Access Compliance Report

Public Rights-of-Way

Intersection ID: 22492	Main Street: SHARON_LAKES_RD	Cross Street: LAKEHOUSE_LN	Location:	N
ADA ID: 119928D5EDEC	Ramp Type: PerpDiag	Initial Pass/Fail: Fail	Overall Compliance: No	Severity Score: 37.5
Codes/Mitigation Info/Possible Solution		Field Measurements/Component Compliance

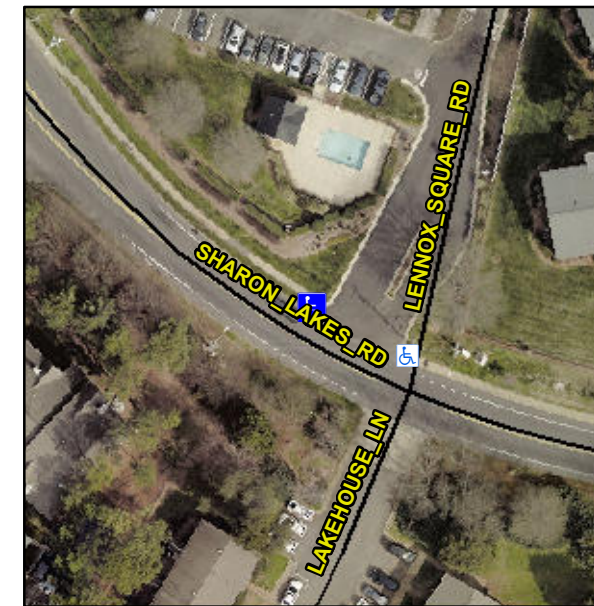
Not Found, R304.2.2, R304.5.3

Compliance	Description	Data	Compliance	Description	Data
N/A	Ramp Length (in)	48.0	No	Ramp Slope (%)	9.2
Yes	Ramp Width (in)	48.0	No	Ramp XSlope (%)	9.0
N/A	Flare Type LT	N/A	N/A	Flare Type RT	N/A
N/A	Flare Slope LT (%)	N/A	N/A	Flare Slope RT (%)	N/A
N/A	Flare Traversable LT?	N/A	N/A	Flare Traversable RT?	N/A
N/A	Landing Length (in)	N/A	N/A	DWS Provided?	N/A
N/A	Landing Width (in)	N/A	N/A	DWS Contrast?	N/A
N/A	Landing Slope (%)	N/A	N/A	DWS Length (in)	N/A
N/A	Landing X Slope (%)	N/A	N/A	DWS Full Width?	N/A
N/A	Landing Curb? (Y/N)	N/A	N/A	DWS Offset (in)	N/A
N/A	Shared Landing?	N/A			
N/A	Gutter Ponding?	N/A	N/A	Gutter Slope (%)	N/A
N/A	Gutter Lip Ht (in)	N/A	N/A	Gutter X Slope (%)	N/A
N/A	Painted X Walk1?	No	N/A	Painted X Walk2?	No
	X Walk 1 Direction	To SW		X Walk 2 Direction	To SE
N/A	X Walk 1 Width (in)	N/A	N/A	X Walk 2 Width (in)	N/A
	X Walk 1 Slope (%)	4.4		X Walk 2 Slope (%)	6.0
	X Walk 1 X Slope (%)	4.3		X Walk 2 X Slope (%)	4.2

Remove & Replace Curb Ramp With Two New Directional Ramps or Equivalent.
